REGIONAL REVIEW NOTIFICATION

ARC REVIEW CODE: R2006191

Name of Proposal: Chappell Road DRI #3096

CHAPPELL ROAD DRI
City of Atlanta
Natural Resources Group Review Comments

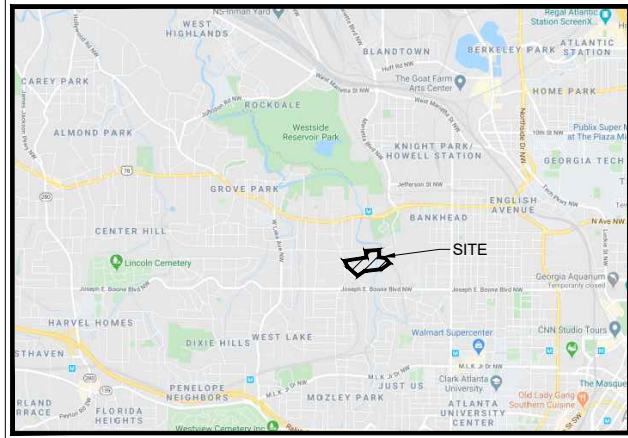
From an urban design perspective, it's not clear whether the proposed orientation of the multifamily buildings and commercial buildings are compatible with BeltLine Overlay requirements for street-oriented

design and accessibility. The project is being rezoned to Planned Development Mixed-Use (PD-MU), but the site plan should still implement all the standard requirements of BeltLine development, especially along Chappell Road and Mayson Turner Roads. The commercial buildings should be oriented and accessible to pedestrians. The placement of parking spaces at Driveways A and B facing Mayson Turner Road may be in violation of BeltLine Overlay requirements. The site plan currently proposes using the existing sidewalk on the frontage, which is barely adequate and in violation of ADA requirements at several locations. The project should be required to build this frontage to all standard BeltLine Overlay requirements for sidewalk and supplemental zone. Atlanta's zoning ordinance clearly states for PD-MU districts "That general commercial and service uses shall be concentrated for maximum pedestrian convenience ... "

The project can further support The Atlanta Region's Plan in general by incorporating other aspects of regional policy, including green infrastructure and/or low-impact design, e.g., pervious pavers, rain gardens, vegetated swales, etc., in parking areas and site driveways, and as part of any improvements to site frontages. Those features are critical to protecting the watershed of a rehabilitating Proctor Creek, which is planned as a significant amenity as it passes through the DRI site. Additional comments from ARC's Natural Resources Group are attached and note that the site plan shows multiple intrusions into the City of Atlanta's 75-foot undisturbed stream buffer that may require variances.

Proctor Creek runs north-south through the project property. No other streams are shown on either the submitted site plan or the USGS coverage for the project area. Both the City of Atlanta's 75-foot undisturbed stream buffer and the State 25-foot Sediment and Erosion Control buffer are shown along Proctor Creek. The site plan shows intrusions into the 75-foot buffer by proposed roads and driveways. In addition, three townhouse buildings are shown abutting the 75-foot buffer on the east side of Proctor Creek, requiring land disturbance within the buffer during construction. Any intrusions into the City's 75-foot buffer may require a variance. Any intrusions into the State Sediment and Erosion Control Buffer may also require variances. Any unmapped State waters identified on the property will be subject to the State 25-foot Sediment and Erosion Control buffer.
